DRAWING TITLE
FT. ROUGE BUS GARAGE
PARKING BAY 3 --DRAVO--
MAKE-UP AIR UNIT WIRING DETAIL
TYP. FOR MUA-20 THRU 26

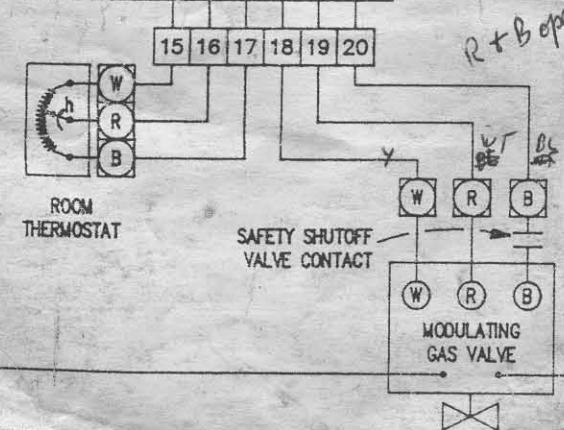
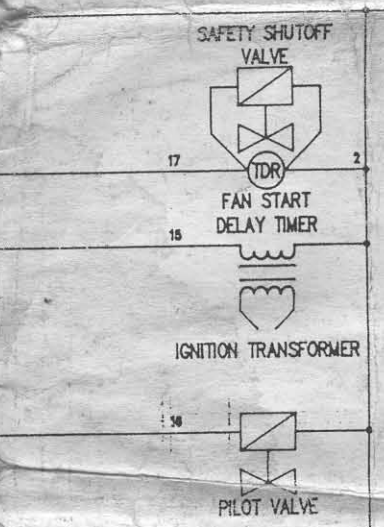
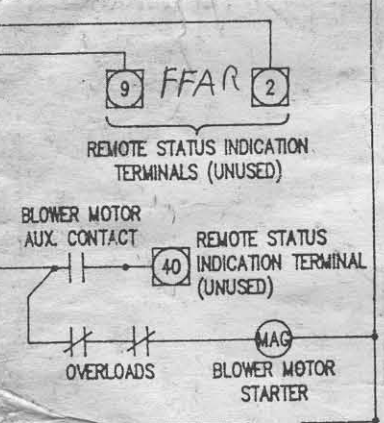
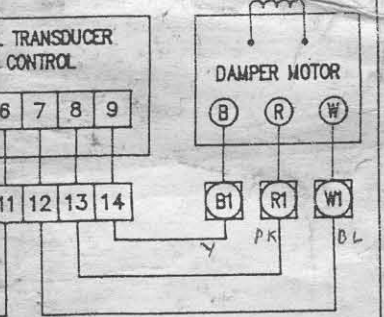
*RA 890 only
wire omitted for
7 wire control*

Flame signal must be
min 24A DC.

Pilot is 34A

main flame 3-44A

High fire 4-54A
